## REMARKS

Claims 1-8 and 10-17 were examined and reported in the Office Action. Claims 1-8 and 10-17 are rejected. Claims 1-2, 4, 8, 10 and 16-17 are amended. Claims 1-8 and 10-17 remain.

FIG. 2

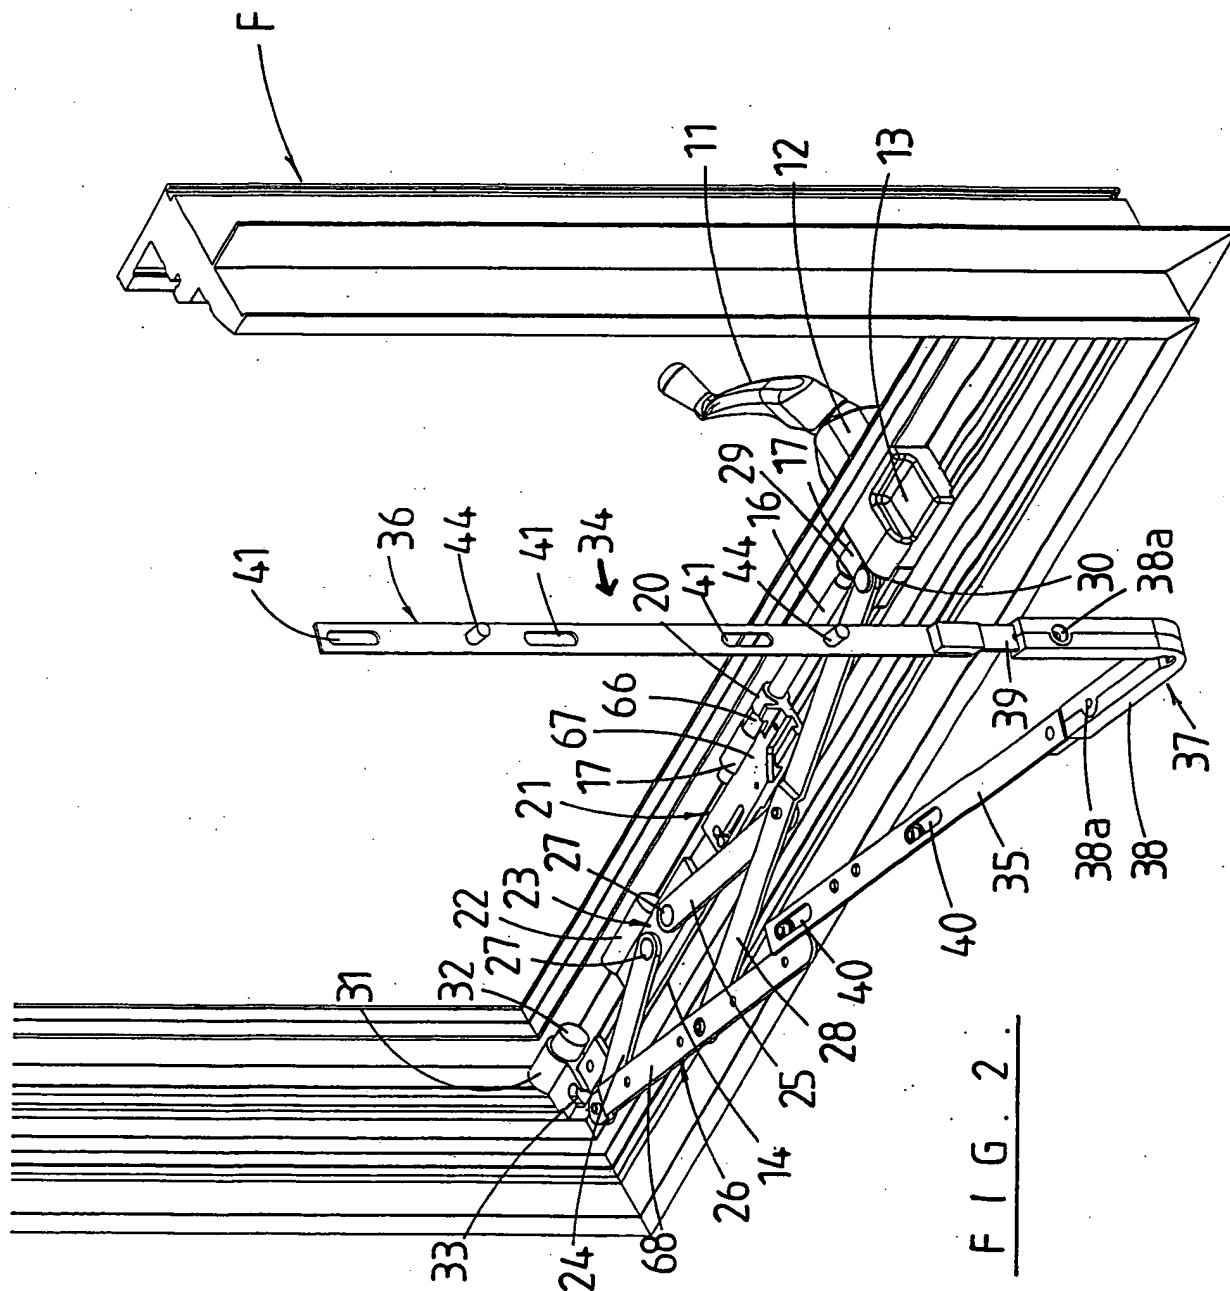
It is asserted in the Office Action that in Figure 2, reference numeral 34 has no lead line. Applicants have amended Figure 2 to include a lead line for reference numeral 34. Approval is respectfully requested.

Dwg  
Correction  
Approved  
5/14/04  
DPS
